VIA EMAIL: council.comments@slcgov.com
Salt Lake City Council
SALT LAKE CITY CORPORATION
451 South State Street, Room 326
Salt Lake City, Utah 84111
cc Via Email: Jackie Biskupski,
mayor@slcgov.com

Re: Is Moving the 4th Ave Well a Feasible Alternative?
General Comments to the Salt Lake City Council

Figure 2 – Assessor Parcel Map Near North Temple and State Streets

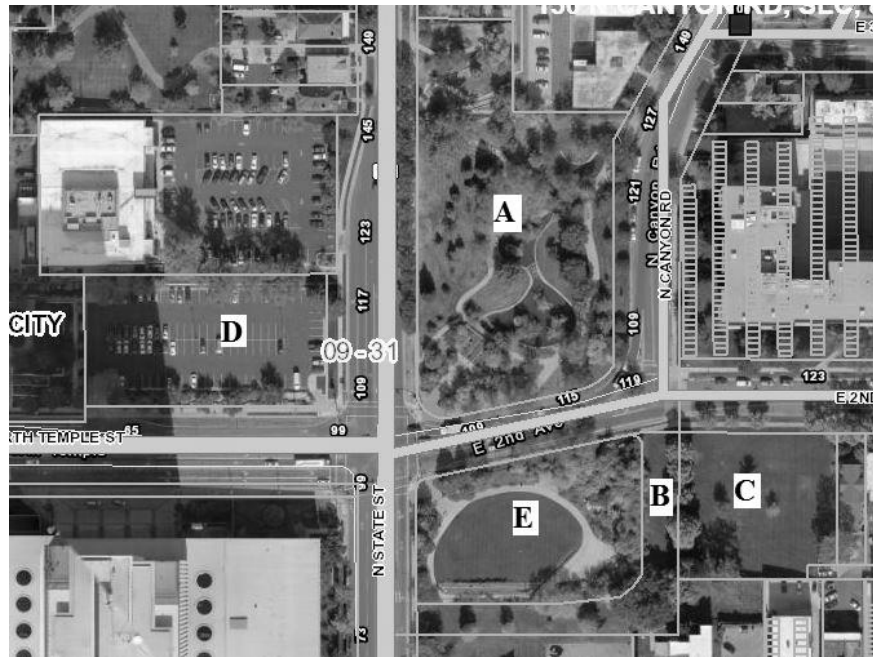
Figure 2 show several parcels to the south of 200 North Canyon Road near State and North Temple per the Salt Lake County Assessor’s Office.¹⁹ Table 1 describes those parcel and Table 2 estimates acquisition costs based on assessor records. Parcel A is owned by Salt Lake City Corporation and has no cost. Parcel “D” is owned by the Church who might be approached to donate a portion of their land’s values considering their extensive experience. Although Parcel “B” is privately owned and its irregular shape lends it to be desirable for a developer to sell. Parcel “E” is excluded as a possible alternative because its size is insufficient to accommodate a one-quarter acre facility.

As shown in Table 2, the DPU's conclusion that no property is available or could not be purchased at a reasonable price appears to warrant further review in the future administration report on alternatives.
